RE: Clause 23 Second Further Information Request – Private Plan Change Request by Windsor Park Community and Multisport Hub Incorporated

APPENDIX 1: FURTHER INFORMATION REQUESTED UNDER CLAUSE 23 FIRST SCHEDULE OF THE RESOURCE MANAGEMENT ACT 1991

APPENDIX 2:
SUGGESTED CHANGES TO PRECINCT PROVISIONS

Figure IXXX.6.1.3.1 Height in relation to boundary

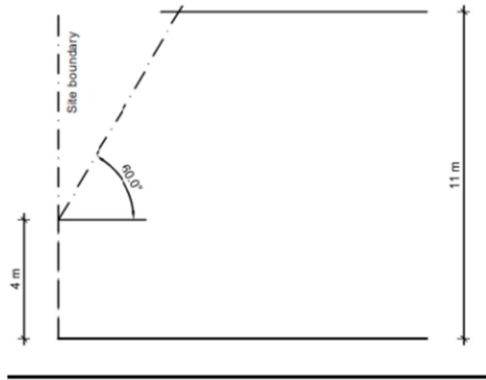
Commented [SW16]: Suggest addition of standard points (2)-(4) to address Sch 3A cls 12(1) sentence two, Sch 3A cls 12(2)(b), and to specify exclusions where the HIRB standard does not apply.

Changes also consistent with AUP HIRB provisions.
